# SJRWMD and SWFWMD Responses to Technical Peer Review Comments Regarding the Preliminary Models and Model Report for the Central Springs Groundwater Flow Model (CSM) version 1.0

January 31, 2024

## **APPENDIX A – TASK D FINAL PEER REVIEW OF CSM v1.0 FINAL DRAFT REPORT (OCTOBER 2, 2023) DOCUMENTATION AND CALIBRATION<sup>1</sup>**

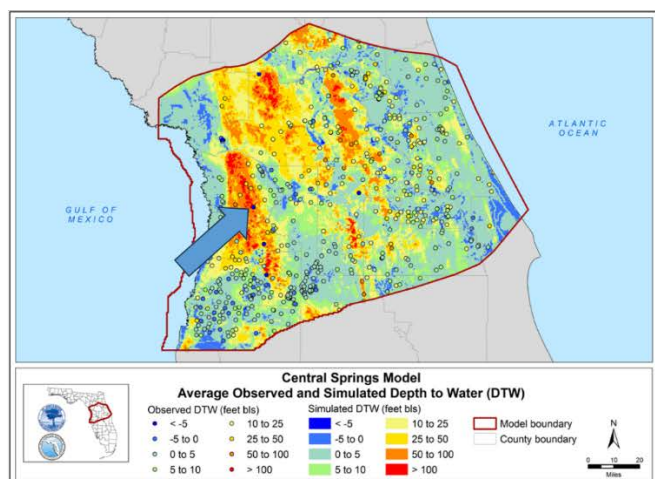
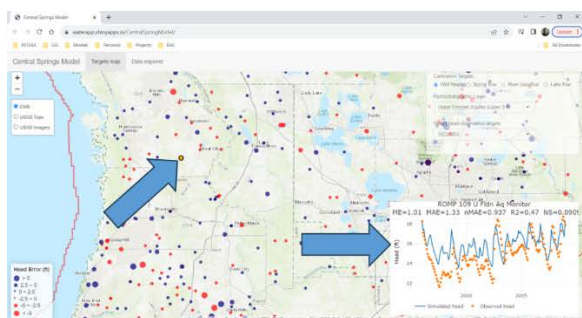
**Comment:** *There are relatively large numbers of flooded and dry cells in Figures 6-13 and 6-14. Revised Figures 6-13 and 6-14 in the draft final report indicate a significant reduction in flooded cells but no significant change in dry cells (only the color for dry cells has been changed from red to brown). In the draft final report (p. 142), it is indicated that the conductances for rivers, lakes, and wetlands were adjusted seasonally in the transient model. This requires further explanation, i.e., what is the basis for seasonally*

*adjusting conductances. Conductances are a physical property of the porous media the water is flowing through. Instead of adjusting boundary condition conductances, maybe other variables such as river and lake stages should be adjusted to achieve the reduction in the numbers of flooded cells.*

9-11	There are relatively large numbers of flooded and dry cells in Figures 6-13 and 6-14.	Not Completely	Revised Figures 6-13 and 6-14 in the draft final report indicate a significant reduction in flooded cells but no significant change in dry cells (only the color for dry cells has been changed from red to brown). In the draft final report (p. 142), it is indicated that the conductances for rivers, lakes, and wetlands were adjusted <i>seasonally</i> in the transient model. This requires further explanation, i.e., what is the basis for seasonally adjusting conductances. Conductances are a physical property of the porous media the water is flowing through. Instead of adjusting boundary condition conductances, maybe other variables such as river and lake stages should be adjusted

**Response:** To address concerns regarding the seasonal adjustment of conductance values, the following text was added to Chapter 6 of the final CSM report: "The conductance of rivers, lakes, and wetlands was adjusted seasonally in the transient model based on the seasonality of the recharge. The seasonally adjusted conductance accounts for the geometric variations of rivers, lakes, and wetlands during the wet and dry season. For each RIV/DRN cell, monthly recharge ratios were computed by dividing the recharge in that month by the average recharge value across the entire simulation period. Subsequently, the conductance of the river and wetland cells was adjusted based on the respective recharge ratio in each cell." River and lake stage varied in the transient model based on the available measured data.

To address concerns regarding dry cells, the following text was added to Chapter 6 of the final CSM report: "Areas in which layer 1 is dry generally correspond to regions where the SAS and/or ICU are thin or completely absent. The large areas of dry cells in the western part of the model domain were expected as the UFA in this area is unconfined and the water table can be greater than one hundred ft below land surface. Model-simulated mean depths-to-water table were compared to observed well data (Figure 6-18). The transient simulation compared favorably to the observed data, indicating a deep water table along the Brooksville Ridge and ridges in the Orlando area."

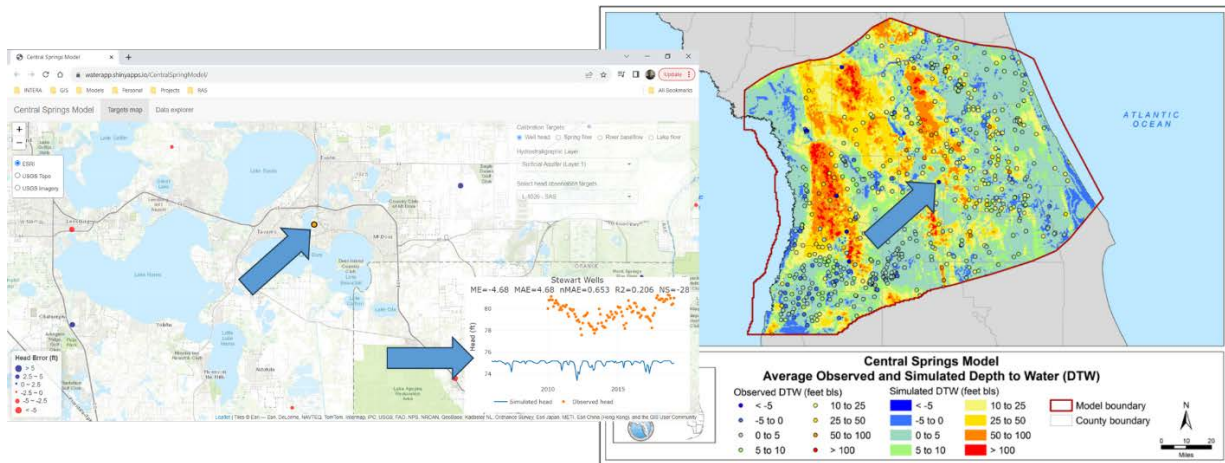
**Comment:** *The District's presentation displays spatial plots of the simulated fluxes slides 45 to 58 depict the simulated fluxes for various model components for the steady-state simulation. These plots could be helpful for the transient simulation. As previously mentioned, these results should be presented in the final report.*

15	Is there pumping from layer 7?	Yes	Pumping was moved to layer 6.
16	Plot a map of CBC flow rates for constant head cells (as well as other boundary conditions)	Not Completely	The District’s presentation displays spatial plots of the simulated fluxes slides 45 to 58 depict the simulated fluxes for various model components for the steady-state simulation. These plots could be helpful for the transient simulation. As previously mentioned, these results should be presented in the final report.
17-18	What are spatially averaged values for rainfall, actual ET, potential ET, and HSPF spatially-averaged annual	Not Completely	This can be achieved by including in the final report the corresponding slides in the District’s slide presentation dated October 2, 2023.

**Response:** Steady-state and transient model boundary condition flux and flux between model layers are provided as figures in Appendix B and Appendix C.

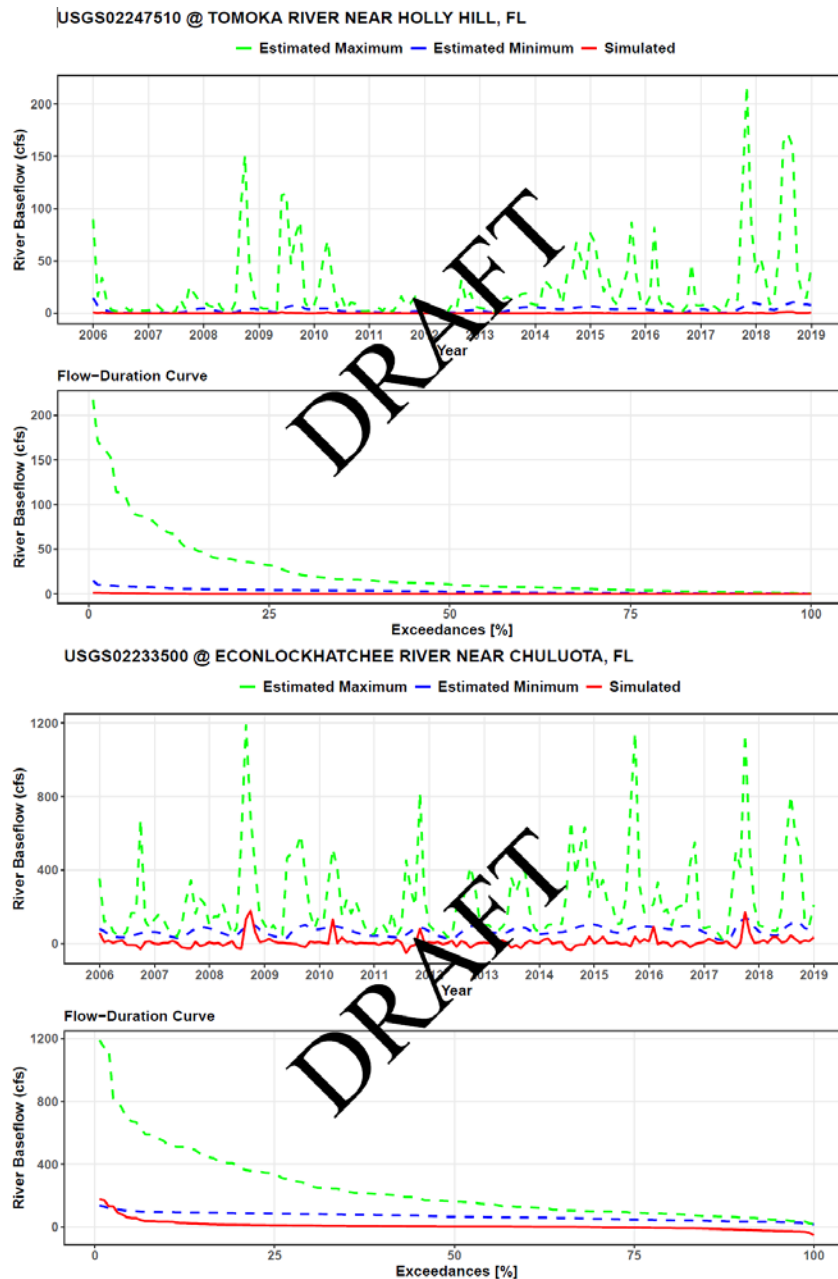
**Comment:** *There seems to be an issue with the graphics in the draft final report and the ShinyApp hydrographs. The dark blue point in the report graphic to the right (depth to water) is shown identified in the ShinyApp on the left. The dark blue color designates water above land yet the hydrograph does not seem to represent water above land issue. It is possible that the cell average topography is erroneously depicting water above land?*

There seems to be an issue with the graphics in the draft final report and the ShinyApp hydrographs. The dark blue point in the report graphic to the right (depth to water) is shown identified in the ShinyApp on the left. The dark blue color designates water above land yet the hydrograph does not seem to represent water above land issue. It is possible that the cell average topography is erroneously depicting water above land?

**Response:** The depth to water at the dark blue color dot was calculated using average topography of that model cell, where the land surface elevation of the well should be used. This was corrected and the simulated versus observed depth to water figure (Figure 6-18) was updated in Chapter 6 of the revised report.

Pickup Baseflow Between  
USGS02312600 @ WITHLACOOCHEE RIVER NEAR FLORAL CITY, FL  
USGS02312762 @ WITHLACOOCHEE RIVER NEAR INVERNESS, FL

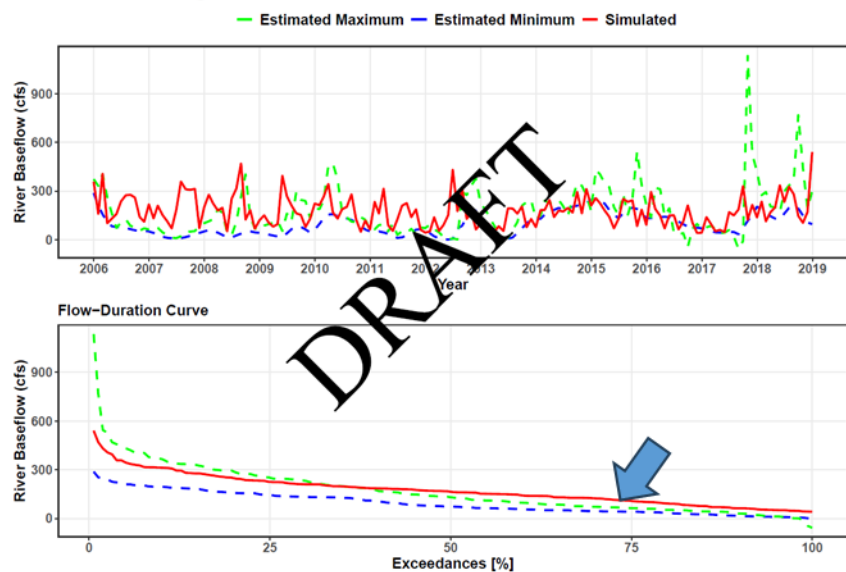
**Comment:** *One example of the need for segmental baseflow analysis is the Floral City-Inverness and Inverness-Holder. Notice the Floral City-Inverness simulated baseflow peaks at about 500cfs with a median of 160cfs (Appendix H pg. 12). While the Inverness-Holder simulated baseflow only peaks at 190cfs with a media of 90cfs. Therefore, an additional 400cfs are available at peak conditions and at median conditions, nearly an additional 70cfs are available.*

Baseflow is overestimated in the Floral City-Inverness segment then underestimated in the next segment downstream, Inverness-Holder.

**Response:** The baseflow in the segment between Floral City and Holder is impacted by the series of controlled structures on the Tsala-Apopka Chain of Lakes. Such controlled flow is not explicitly simulated in the CSM (a groundwater only MODFLOW model). The baseflow simulated in the CSM is a rough estimate of the groundwater exchange with the surface water and does not include other processes contributing the river baseflow. Further analysis of surface water flows is needed to determine the hydrological processes impacting segmental baseflow.

**USGS02239000 @ OCKLAWAHA RIVER NR OCALA,FLA.**

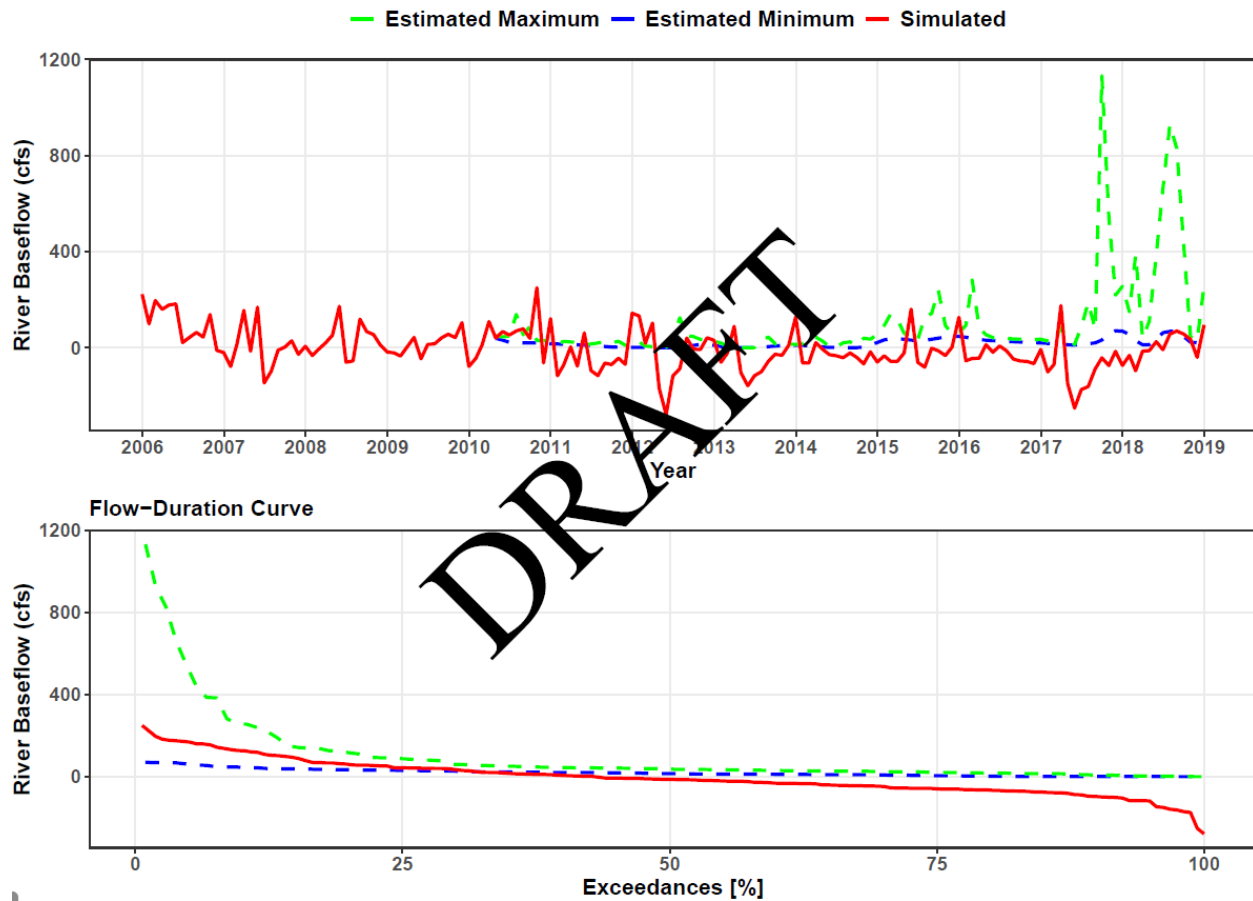
**Comment:** *The Ocklawaha River near Ocala overestimates negative baseflow. The negative baseflow condition persists for more than 50% of the time with an average magnitude of nearly 100cfs. The sign*

*convention depicts discharge from the aquifer to the river as positive. Therefore, the negative baseflow condition of nearly 100 cfs for a majority of the simulation shows the aquifer is receiving water.*

The Ocklawaha River near Ocala overestimates negative baseflow. The negative baseflow condition persists for more than 50% of the time with an average magnitude of nearly 100cfs. The sign convention depicts discharge from the aquifer to the river as positive. Therefore, the negative baseflow condition of nearly 100 cfs for a majority of the simulation shows the aquifer is receiving water.

**Response:** The negative simulated baseflow at the Ocklawaha River, depicting discharge from the aquifer to the river, appears to be isolated at the Ocklawaha River near Ocala, FL gage (02339000). Other stream gages on the Ocklawaha River utilized in the calibration effort, including the Ocklawaha River near Conner, FL (02240000) and Ocklawaha River at Eureka, FL (02240500) resulted in simulated baseflows that were within the range of estimated baseflow values over the model simulation period as well as in good temporal agreement between estimated and simulated baseflow over the model simulation period. Additionally, the time series of HSPF-calculated baseflow (AGWO) generally compares favorably to the MODFLOW simulated baseflow in the Ocklawaha Basin as illustrated in Appendix J (HUC 03080102). Staff reviewed the area of the northern Ocklawaha River basin in the vicinity of Lake Weir and agree with the reviewers that this area should be improved in the next version of the model. Additionally, predictive uncertainty analysis will enable the Districts to quantify the uncertainty associated with predictions of baseflow using the model.
